Amendments to the Drawings:

REMARKS/ARGUMENTS

2/12

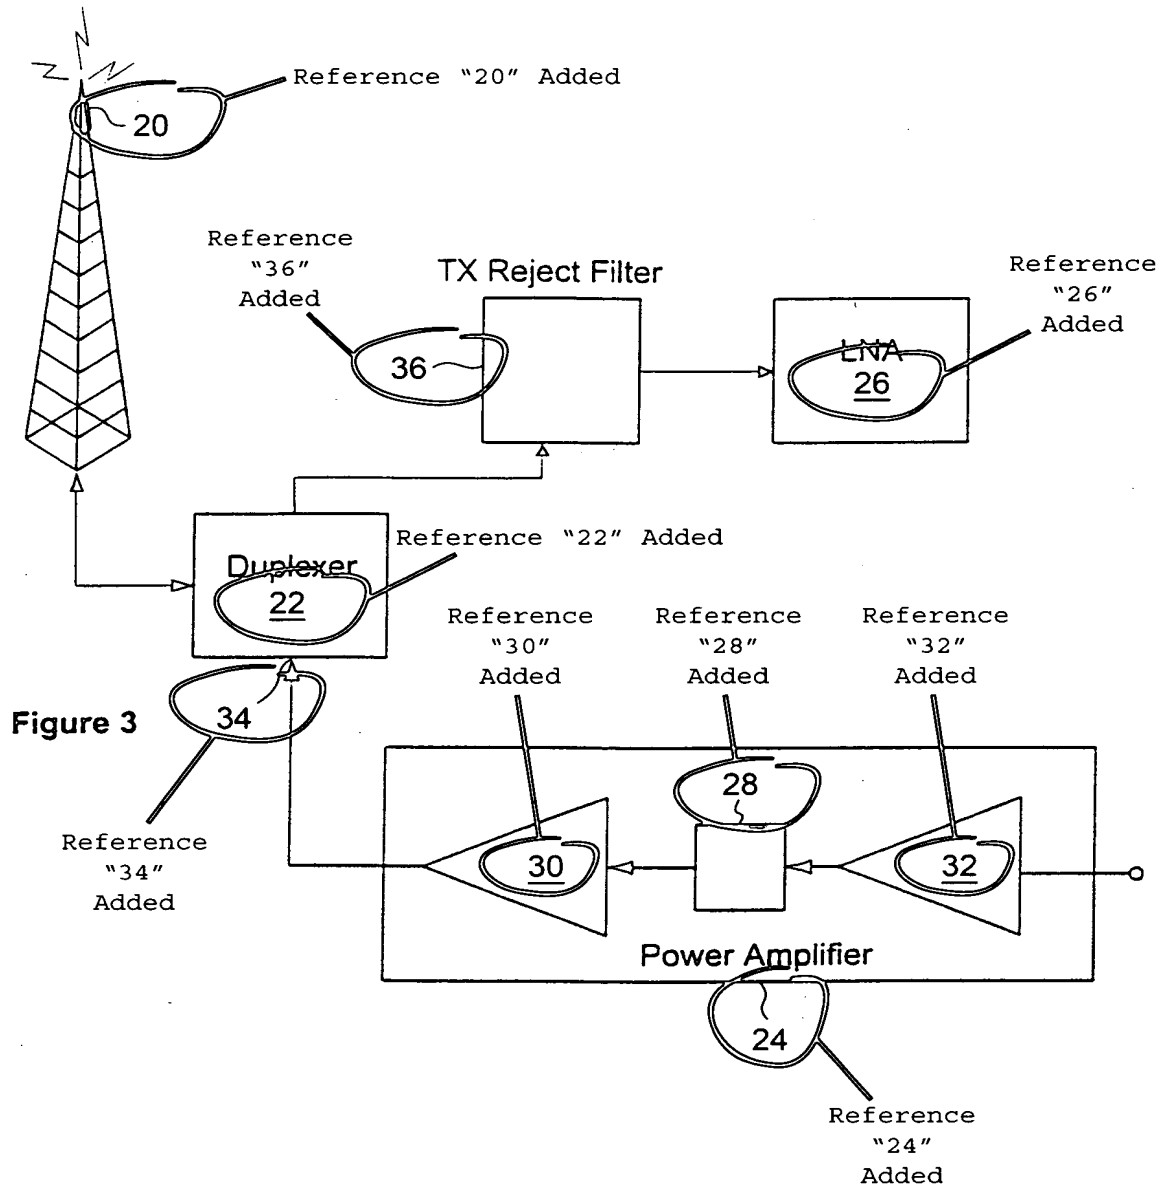
The attached drawing sheet 2/12 includes changes to Figures 3 and 4. This sheet, which includes Figures 3 and 4, replaces the original sheet including Figures 3 and 4. In Figure 3, elements have been labelled with reference numerals “20”, “22”, “24”, “26”, “28”, “30”, “32”, “34”, and “36”. Figure 4 has been amended to label the mobile handset with reference numeral “400”.

Elements in Figure 3 have been labelled with reference numerals “20”, “22”, “24”, “26”, “28”, “30”, “32”, “34”, and “36”, and the mobile handset of Figure 4 has been labelled with reference numeral “400”. The specification has also been amended on page 12, line 26 to replace the reference numeral “40” with “400”. The expression “mobile handset” on page 13, line 1 has been replaced with “mobile handset 400”.

Figure 20A

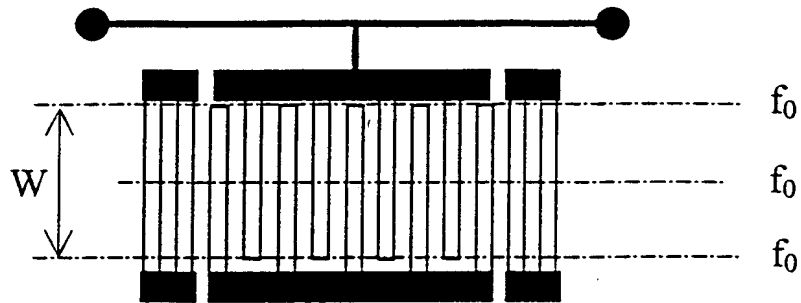
Figure Number
Changed
From "21A"
To "20A"

Figure 20B

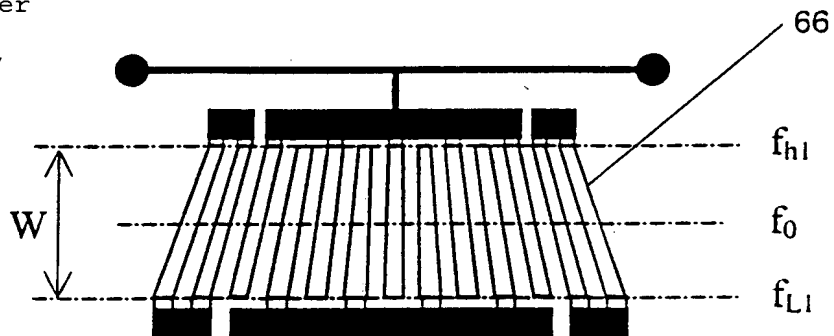
Figure Number
Changed
From "21B"
To "20B"

Figure 20C

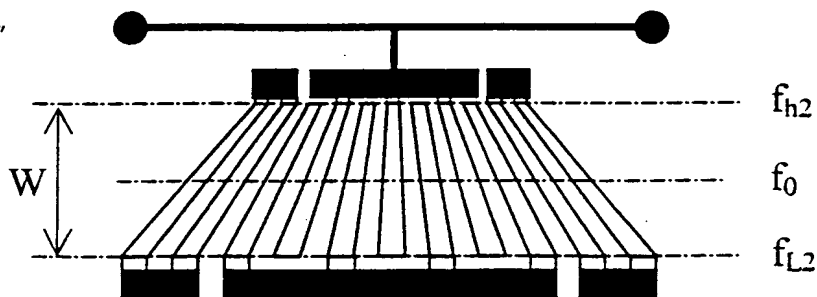
Figure Number
Changed
From "21C"
To "20C"

Figure 21

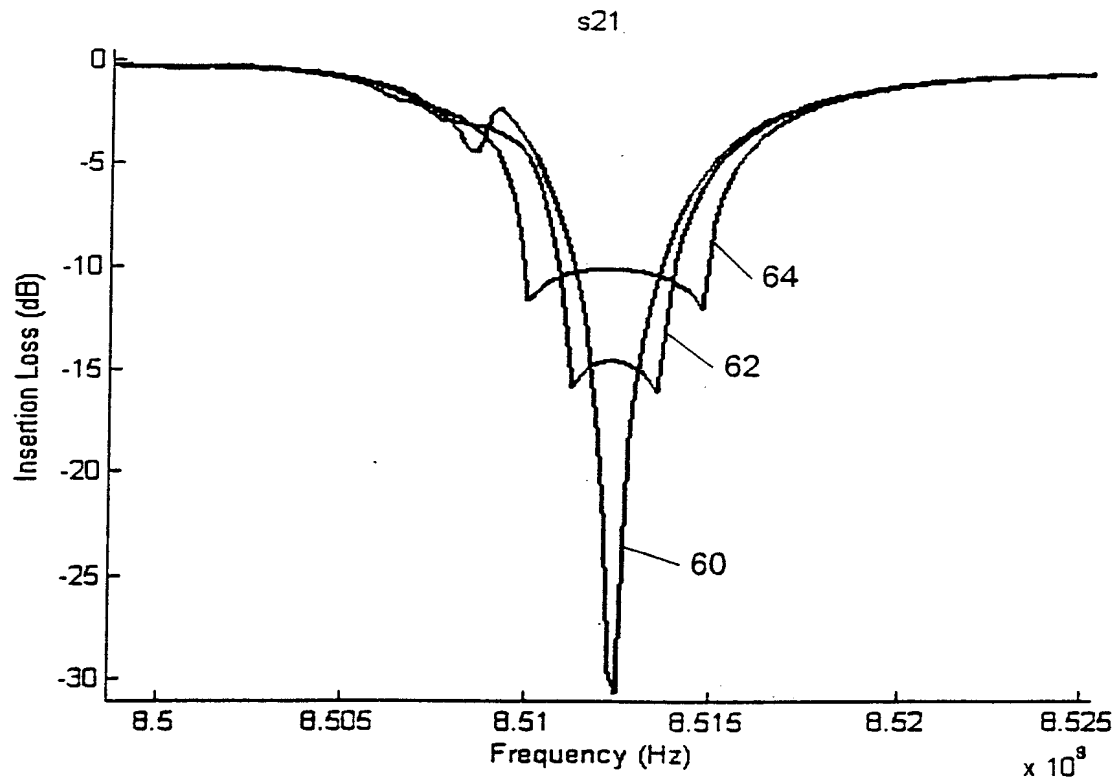
Figure Number
Changed
From "22"
To "21"

Figure 22

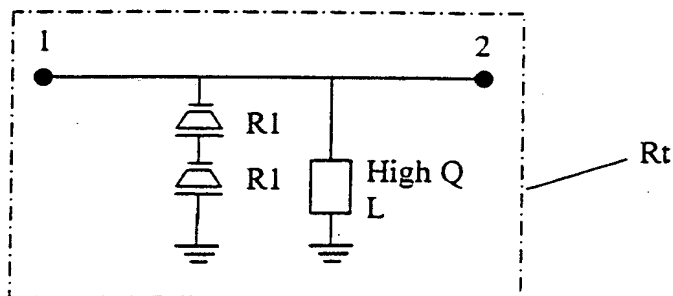
Figure Number
Changed
From "23"
To "22"

Figure 23

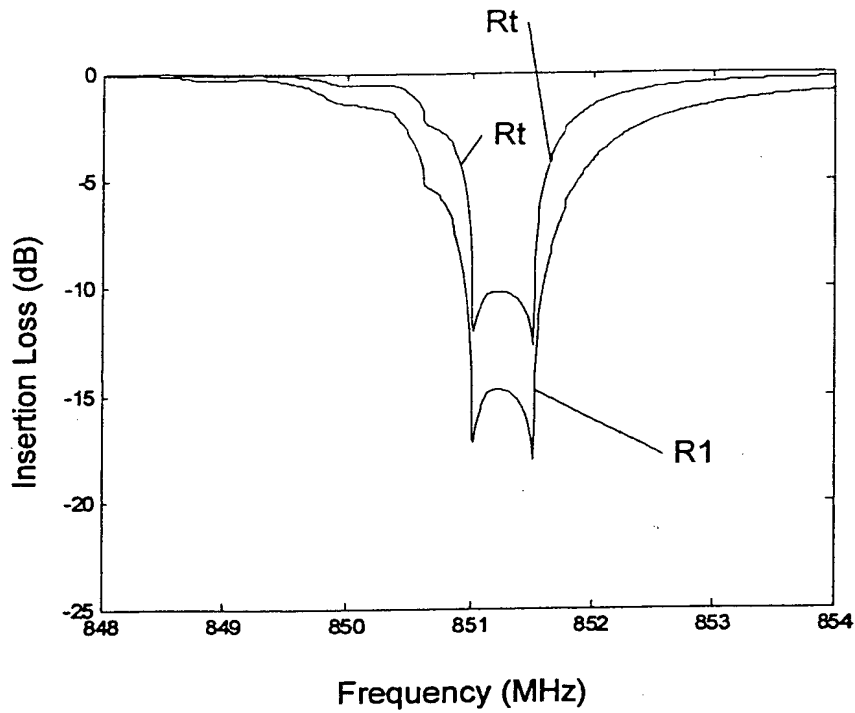
Figure Number
Changed
From "24"
To "23"

Figure 24

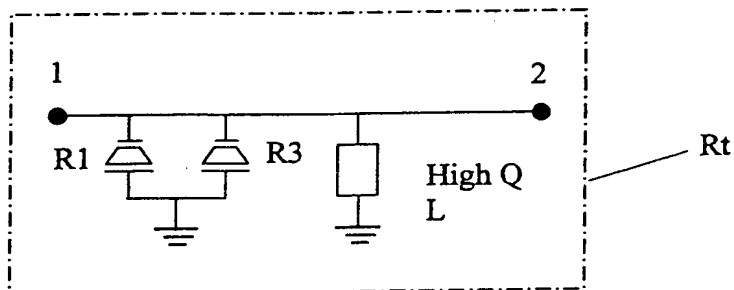
Figure Number
Changed
From "25"
To "24"

Figure 26A

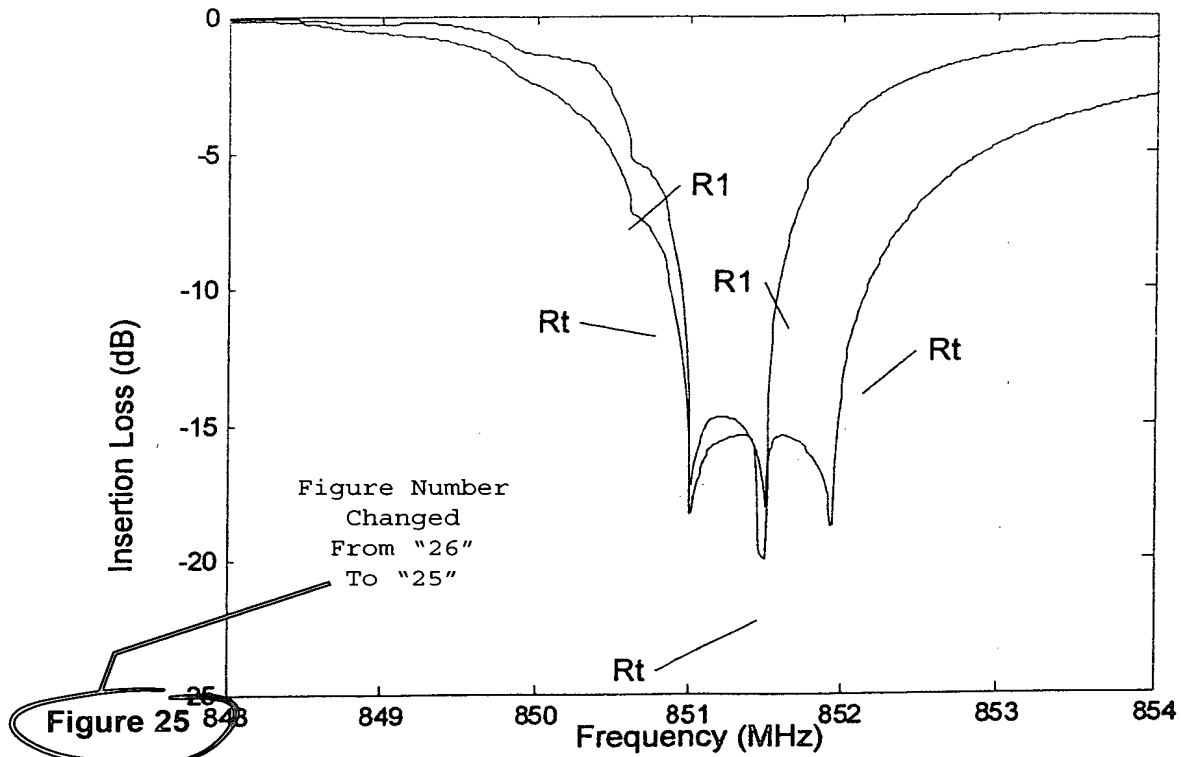
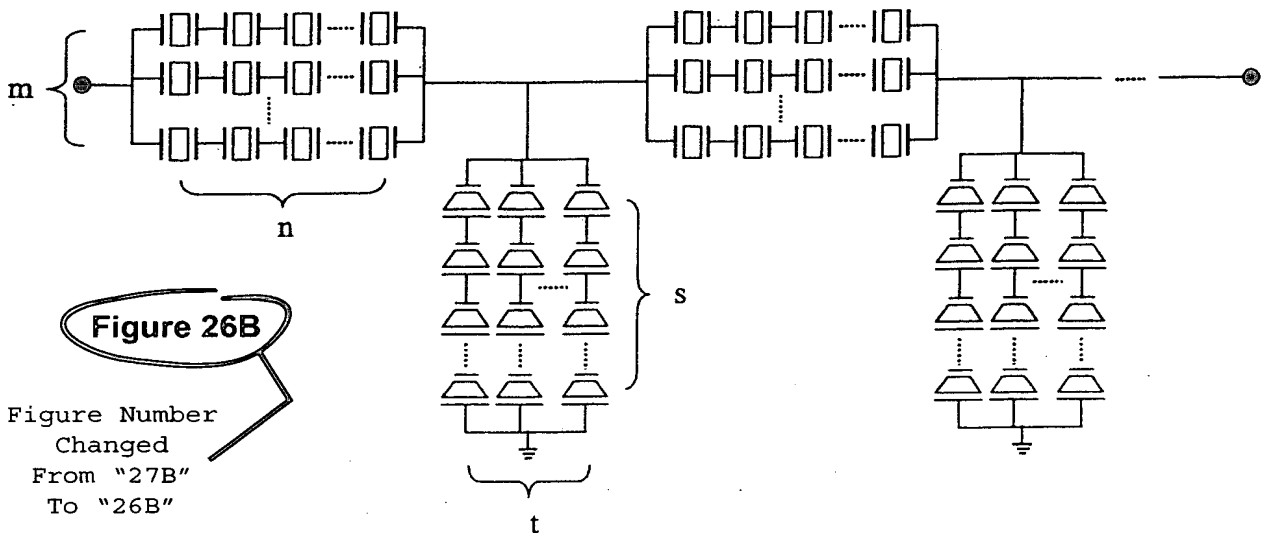
Figure Number Changed From "27A" To "26A"

Figure 28A

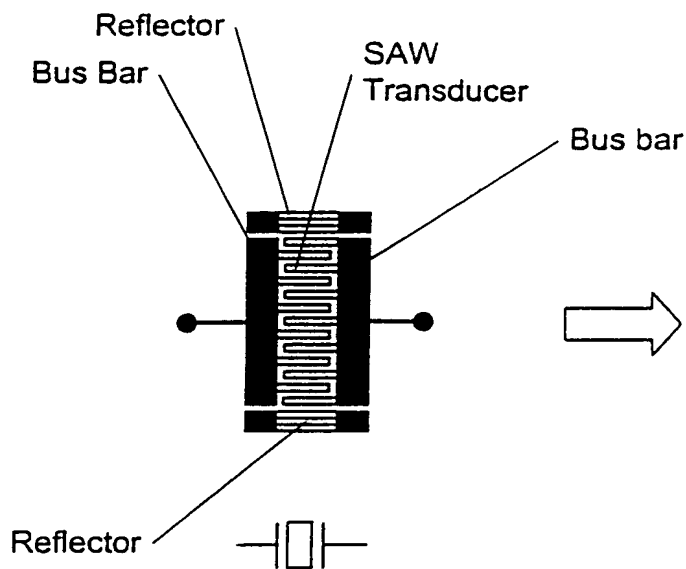
Figure Number
Changed
From "29A"
To "28A"

Figure 28B

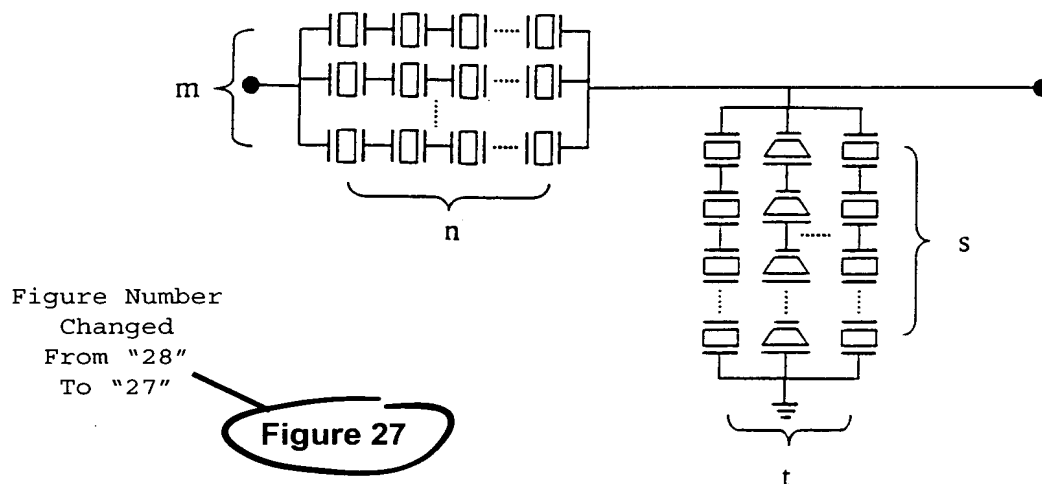
Figure Number
Changed
From "29B"
To "28B"
